ARKANSAS POWER & LIGHT COMPANY

May 6, 1981

SUBJECT: Arkansas Nuclear One - Unit 2  
Docket No. 50-368  
License No. NPF-6  
Responses to NRC Question on the ANO-2,  
Cycle 2 Reload Report  
(File: 2-1510)

ATTACHMENT A

# STEAM COOLING HEAT TRANSFER COEFFICIENTS

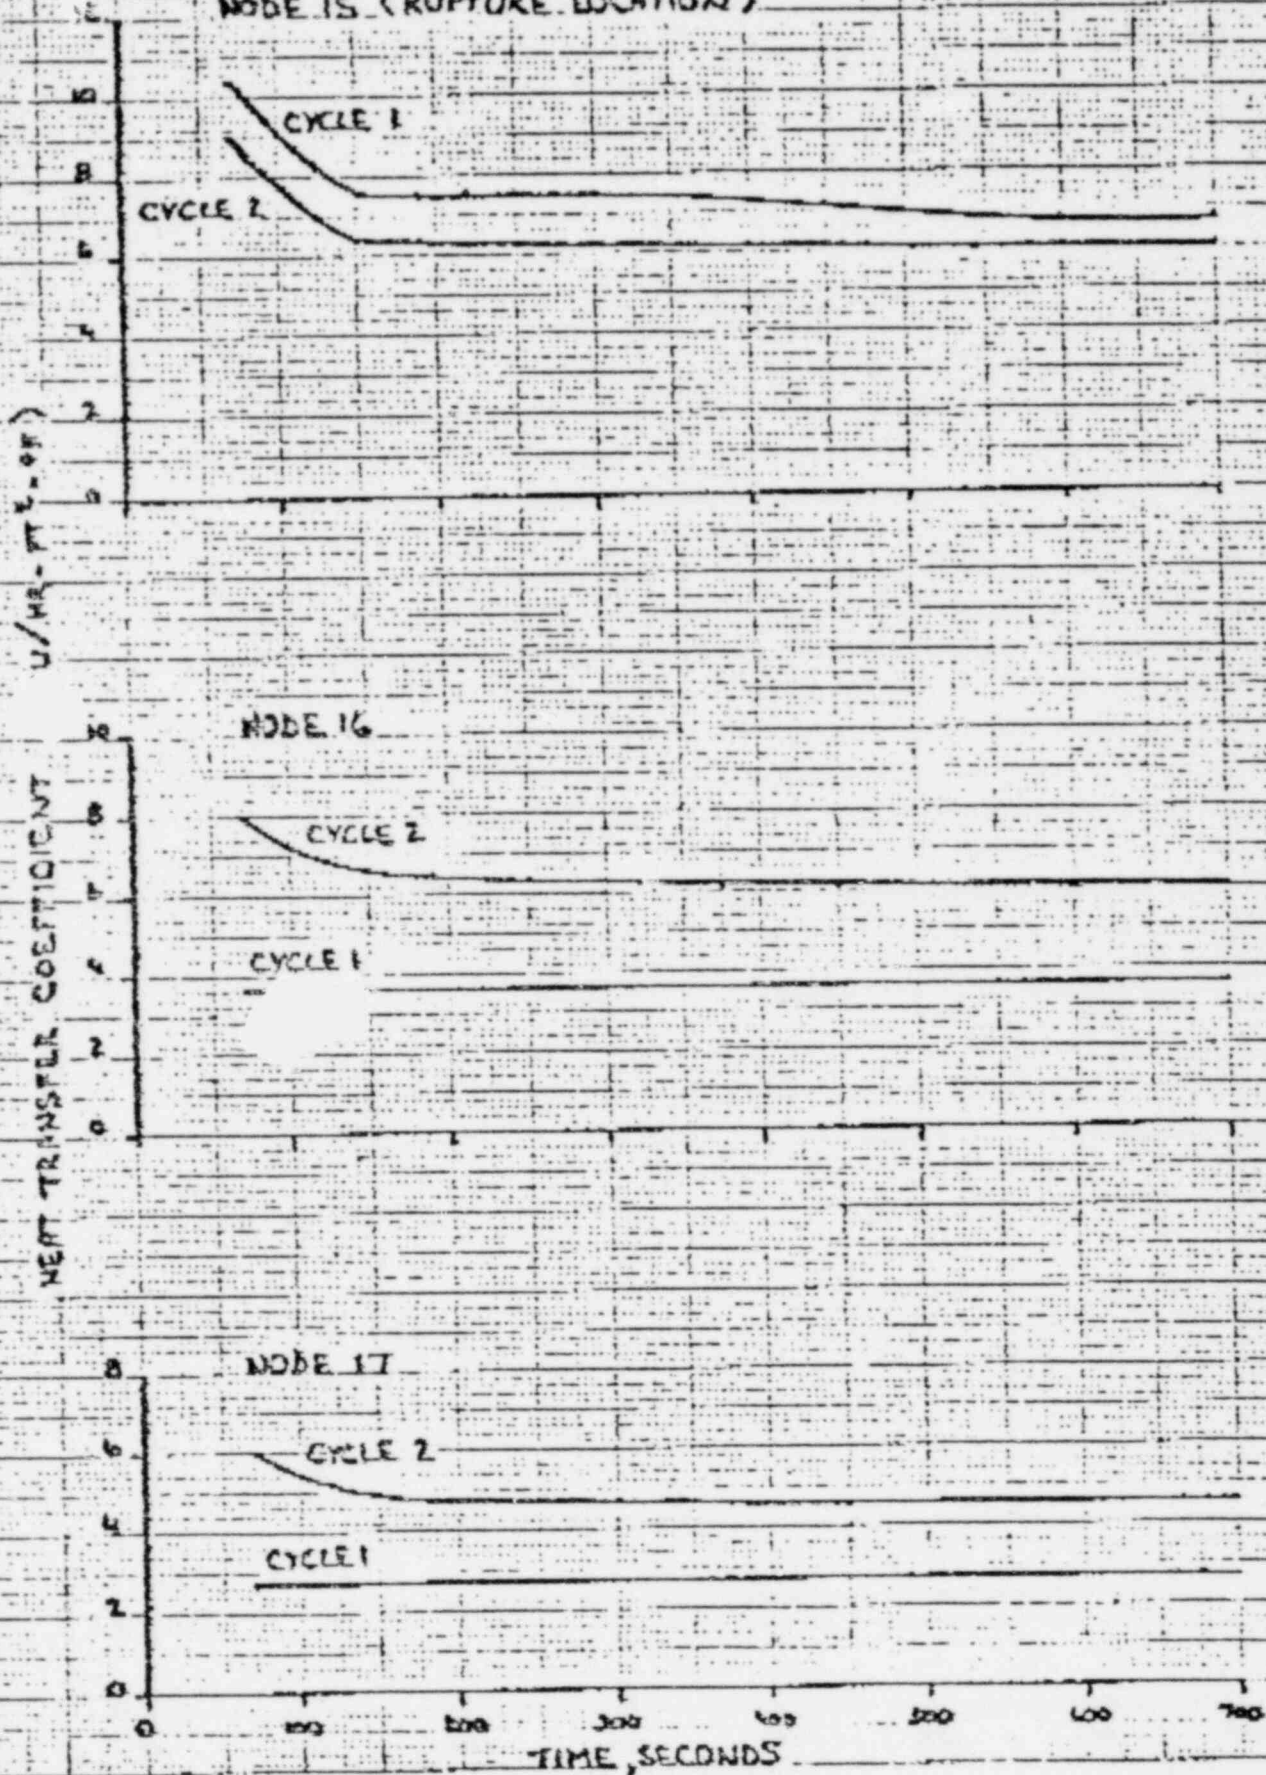
- Q-9  
(8.3) Provide a figure or table showing the values of the steam cooling that transfer coefficient versus axial location for the Cycle 1 analysis and for the Cycle 2 analysis.

Answer The steam cooling heat transfer coefficients (HTC) versus axial location for the Cycle 1 and Cycle 2 analyses are provided in Figure E.1. Steam cooling HTC are applied to the hot rod at and above the rupture location after the core reflood rate first falls below one inch per second (1"/sec). For both Cycles 1 and 2, cladding rupture was predicted to occur at axial mode 15 and the core reflood rate fell below 1"/sec at 71 seconds.

As described in the ANO-2 Cycle 2 Reload Report (Reference 1), the Cycle 2 steam cooling HTC were calculated using the approved PARCH code (Reference 2). For Cycle 1, the steam cooling HTC were calculated using the PARCH code only at the rupture location. Above the rupture location, minimum steam cooling HTC, as described in Reference 3, were conservatively used.

In the Cycle 2 analysis, conservatively generated PARCH steam cooling HTC were used. Otherwise, the PARCH steam cooling HTC for axial mode 15 (rupture location) would have been essentially equivalent in both analyses.
